Our Ref: 3034-01/LK4

PROPOSED CHRISTMAS FARM, LAND TO THE SOUTH OF LLAY ROAD, CEFN-Y-BEDD, WREXHAM

PLANNING APPLICATION REFERENCE P/2022/0681

Introduction

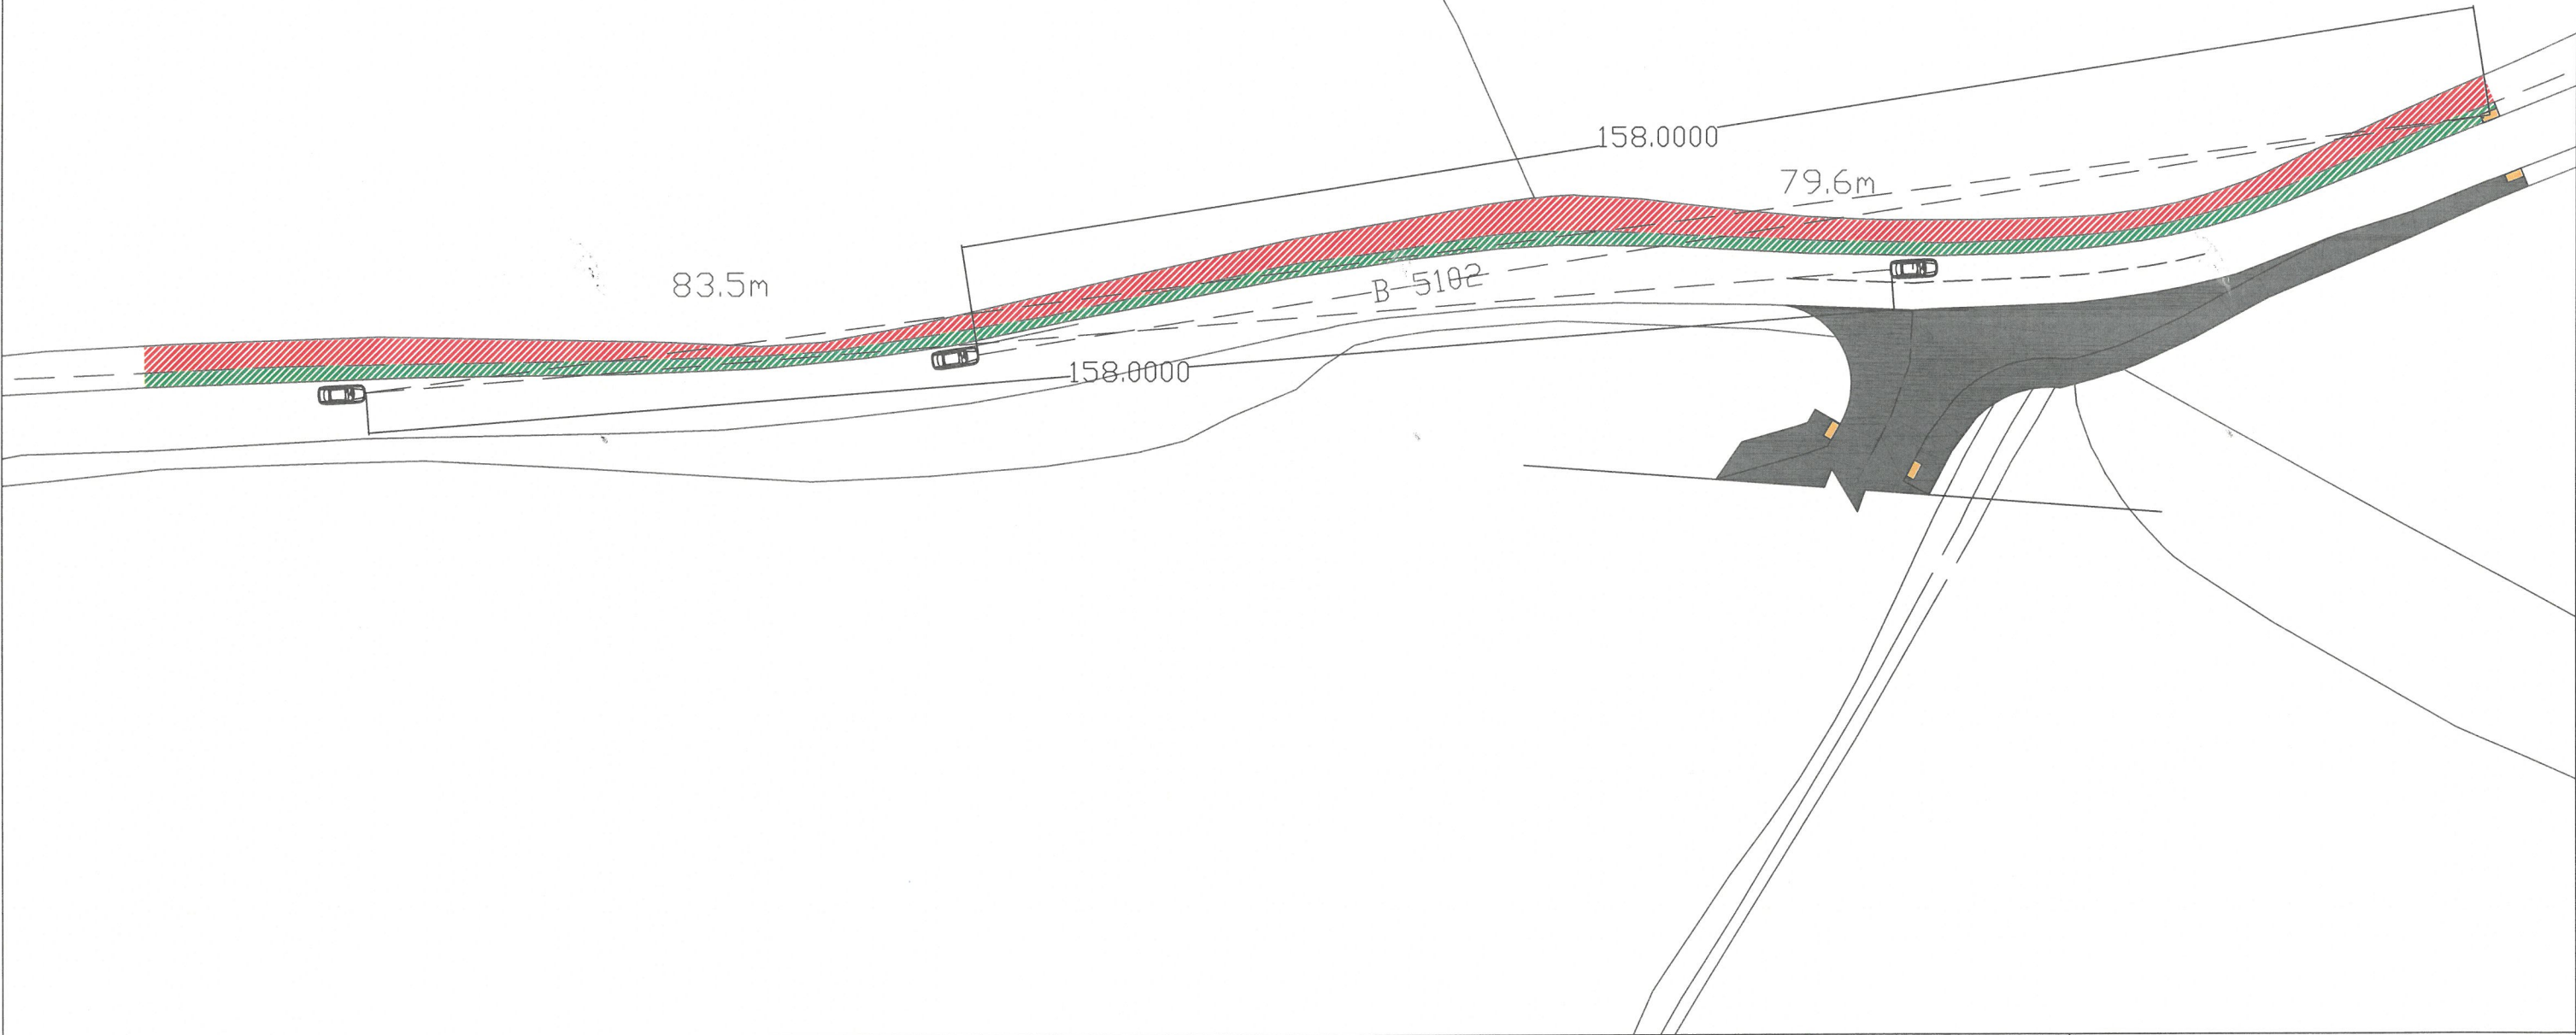
Firstly, it is noted that the red-coloured hatched strip of 'Third Party Land' indicated on the plan appended to the LHA's response is, in fact, adopted highway. The LHA's own records (freely available online here: <https://www.wrexham.gov.uk/service/adopted-roads-map> and also indicated in Axis' response letter dated 3rd March 2023) demonstrate this to be the case.

3. In Highways response dated 3rd February 2023 reference was made to a need for pedestrian visibility on the north side of the road, particularly, looking west from the crossing. We don't believe this has been addressed and attach a plan marked up that demonstrates our requirement better than narrative, and highlighting approximately the third party land across which an agreement would be required (ref ET/DC/PP/P/2022/0681 – dated 3rd February 2023 page 3 and 4). The need for 3rd party visibility on the north side of the road was also highlighted in ET/DC/PP/P/2022/0681 dated 4th July 2023.

The adopted highway boundary record is also fully contiguous with the freehold land ownership boundaries on either side of Llay Road, as indicated on the Land Registry website, thus providing complete confidence in the accuracy of those records.

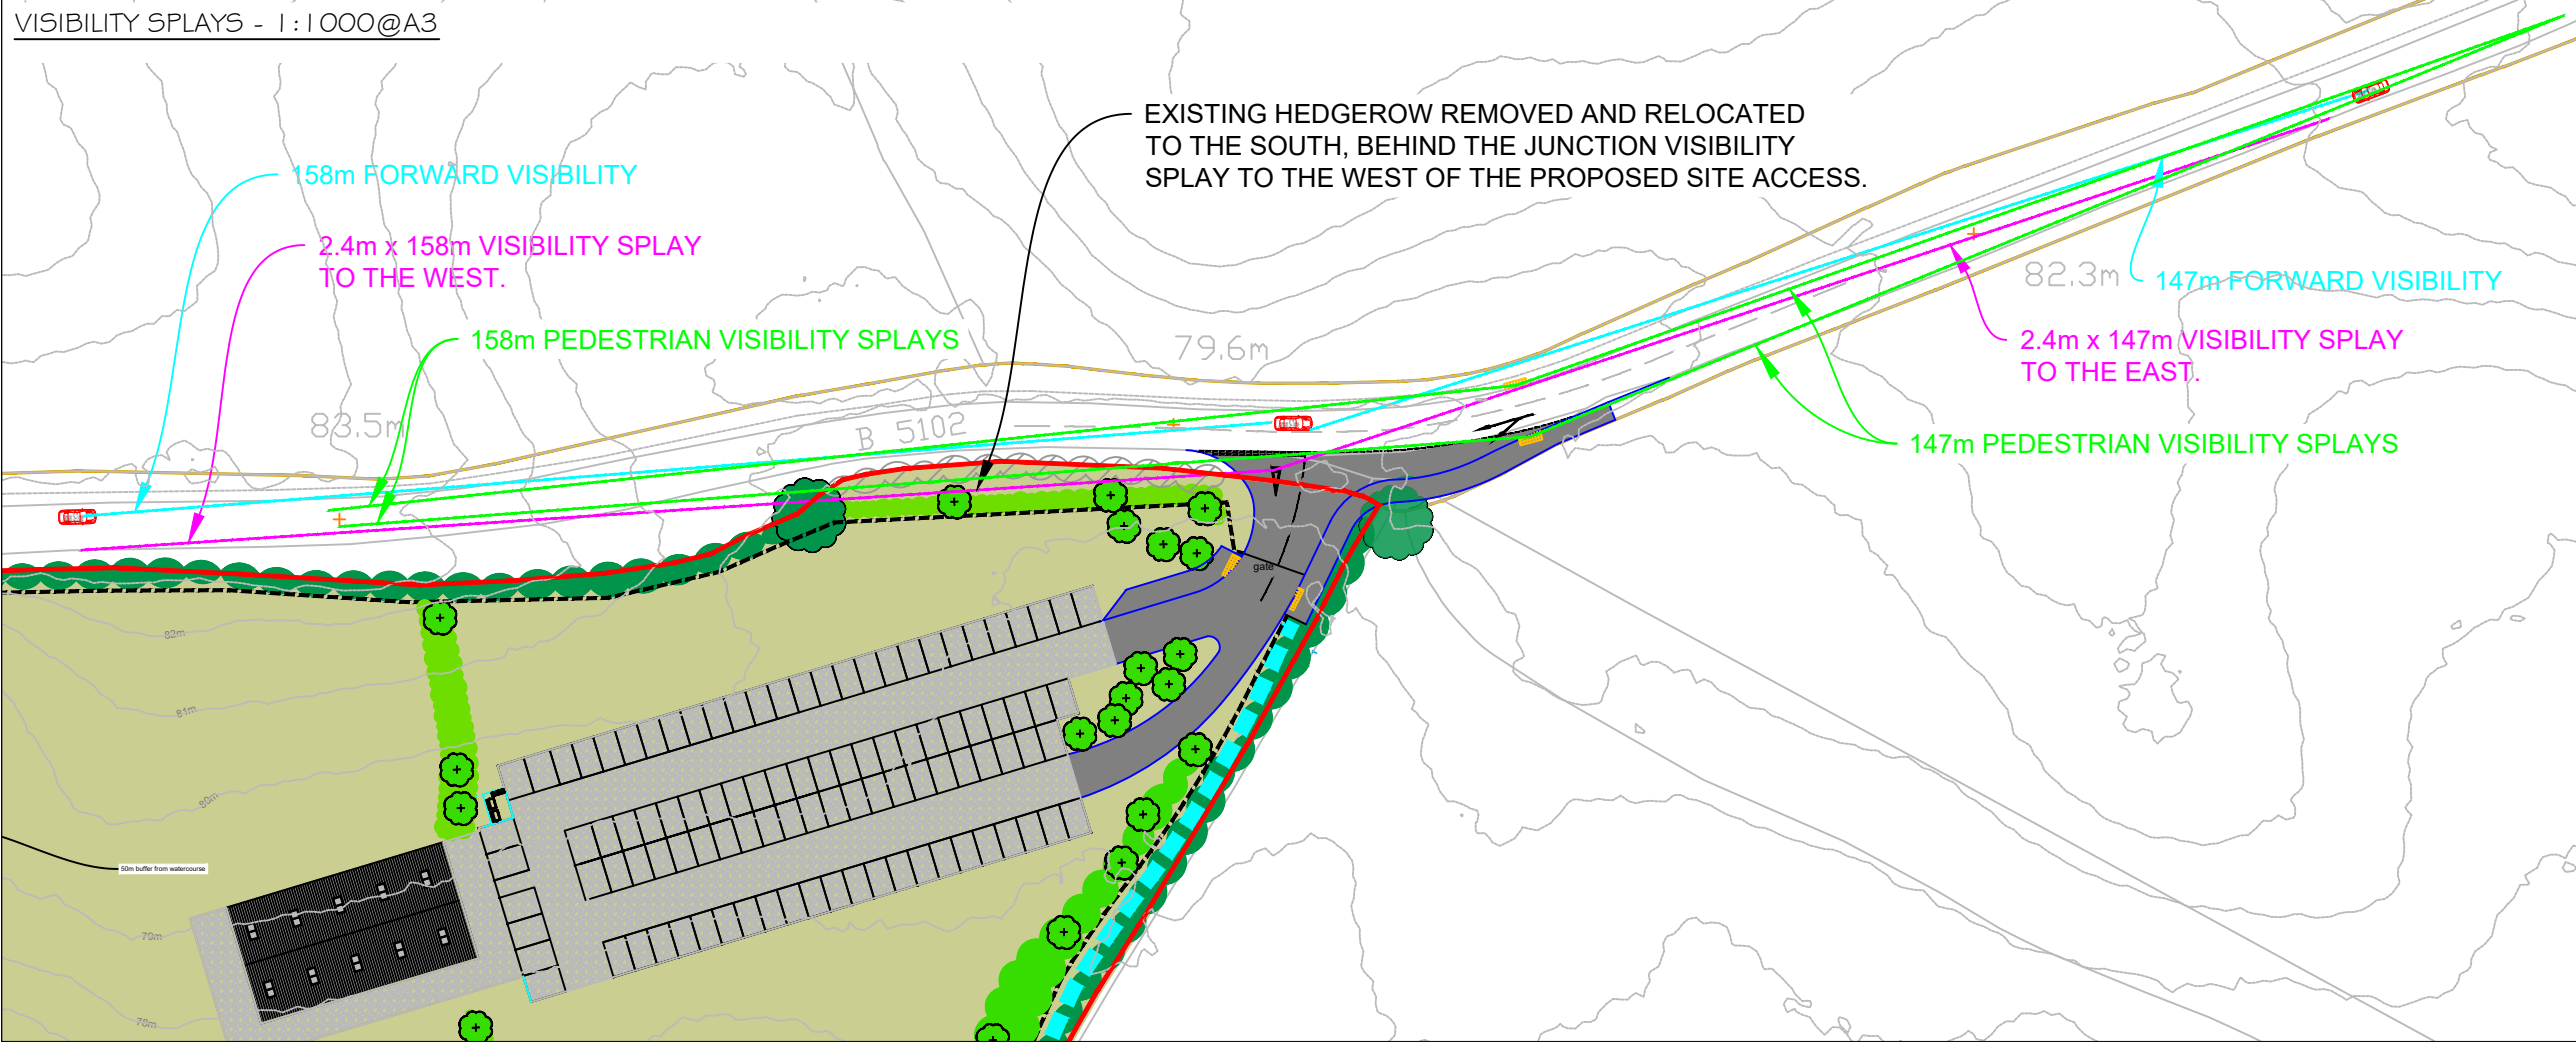
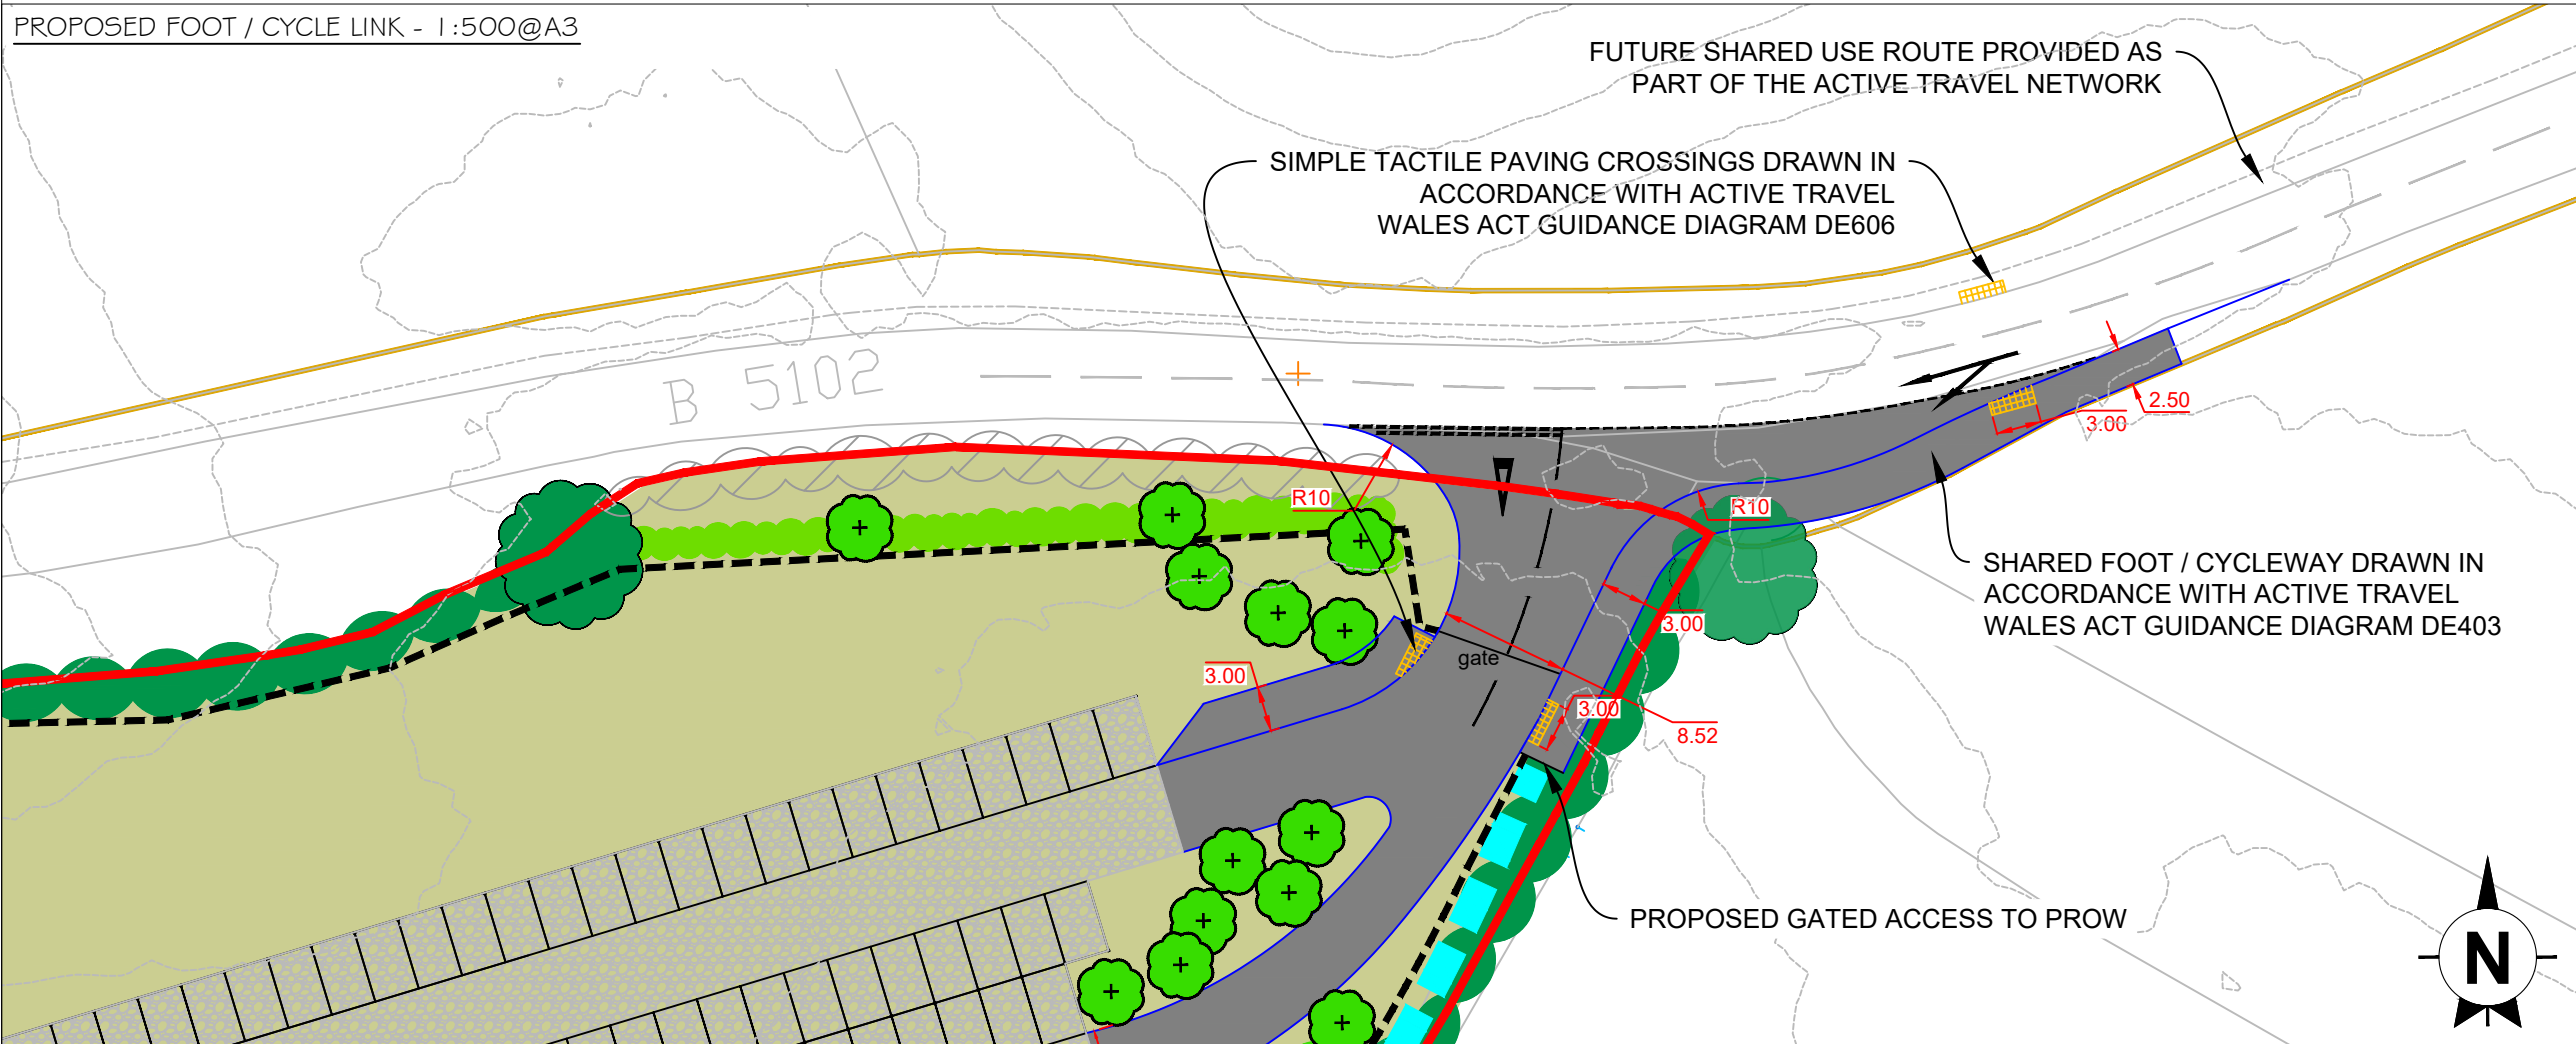
Comments: *“To enable us to reconsider our response in the future, we would need to see...2. Demonstration of safe pedestrian crossing onto the footway from the site, with adequate visibility east and west, and for distances circa 150m in light of the 50mph recorded 85 percentile survey results. These could be reviewed if traffic speeds were reduced via a TRO local to the crossing.”*

Nonetheless, in an effort to address this point we have re-examined the proposed site access arrangements and have relocated the pedestrian crossing further west, closer to the site access again.

This is shown on **drawing 3034-01-D03 Rev C**, enclosed with this letter.

From the relocated pedestrian crossing location, the drawing demonstrates that it would be possible to see further than the 158m stopping sight distance (SSD) requirement to the west and further than the 147m SSD requirement to the east. In other words, a pedestrian waiting to cross at this location would be able to see oncoming vehicles for a safe distance and take an informed decision on whether it is safe to cross the road.

We would also wish to reiterate the points from our 11th September 2023 letter, that the 158m and 147m SSDs are based on speed readings undertaken in July 2021, and that after this date, vehicle activated speed warning signage was installed in the nearby layby, facing westbound traffic. According to DfT guidance, this is likely to have slowed traffic down by between 3mph to 9mph.

The visibility splays that have been shown to be achievable are therefore likely to be robust.

It is therefore considered that the revised crossing location satisfactorily addresses this concern, and a TRO that reduces the speed limit is not necessary.

Revision History		Date
A	FOOT / CYCLE ARRANGEMENT REVISED PER COMMENTS BY ACTIVE TRAVEL OFFICER	04.11.22
B	FOOTWAY EXTENDED TO EAST AND TACTILES ADDED	17.2.23
C	PEDESTRIAN X-ING RELOCATED BACK WEST	26-09-23
